**EAST COVENTRY TOWNSHIP  
CHESTER COUNTY**

**RESOLUTION NO. 2016 - 05**

2. This Resolution shall be known and may be cited as the "Resolution for Preliminary Reverse Subdivision and Land Development Plan Approval for Construction of the New East Coventry Elementary School."

**PRELIMINARY PLAN**

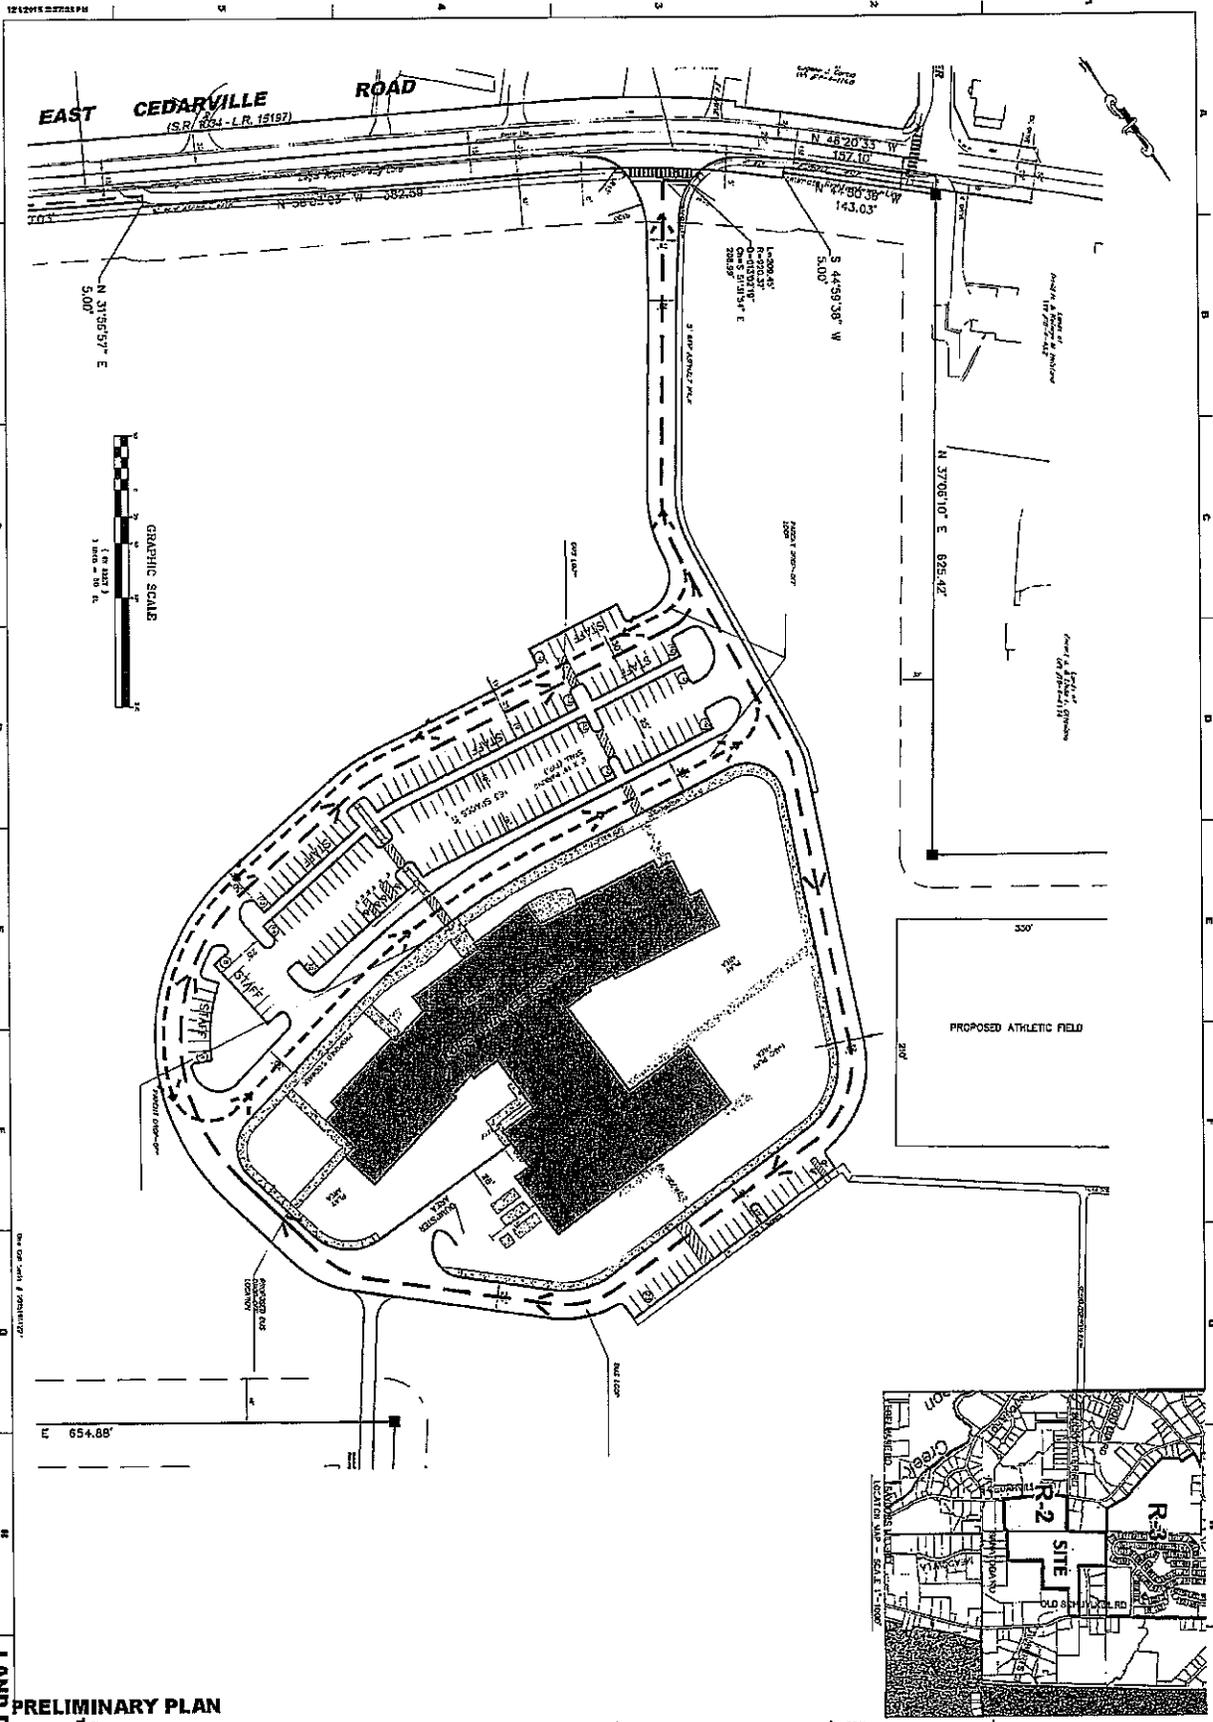
40. As part of the final plan submission, the Applicant shall re-design the interior circulation, drives and parking areas on the Property and shall implement traffic control measures to improve pedestrian safety and the ability of vehicles to execute parking maneuvers by providing greater separation of pedestrians, parking facilities and vehicular traffic, substantially, as shown on the marked site plan attached hereto as Exhibit "B" and incorporated herein by reference, in accordance with Zoning Ordinance §§1306.C(1) and 1306.D(1)(a). The re-design based on the revisions to the site plan to be prepared by G.D. Houtman and Sons, Inc., shall improve the site circulation compared to the plan, as initially proposed. Specifically, changes shall be made to eliminate the row of 20 parking spaces on the outside drive aisle, and relocate them to the middle drive aisle. The remaining row of 18 spaces in the outer drive aisle will be listed as staff parking and shifted northwest on the site as much as possible and the drive aisle will be widened to thirty feet (30'). A pedestrian crosswalk will be included in the area of the relocated parking to link to the existing sidewalk on the northwest end of the building.

Parents dropping off and picking up children will be directed to the outside (curbline) of the outer drive aisle and will turn left just west of the bus drop-off/pick-up point and proceed west down the main drive aisle in front of the school building, as this will increase queuing storage area on site. Intersection control (all way stop signage) will be installed at the easternmost intersection where buses and cars cross, and staff should assist during peak times to ensure safe passage of the buses.

The foregoing plan changes are intended to alleviate concerns of parents dropping off and picking up students who need to park and escort their child into the building that could be parked in (blocked) by queuing cars extending back from the drop-off point, will greatly reduce the potential vehicle conflicts with pedestrians within the parking aisles during the main drop-off and pick-up times, and will improve traffic operations.
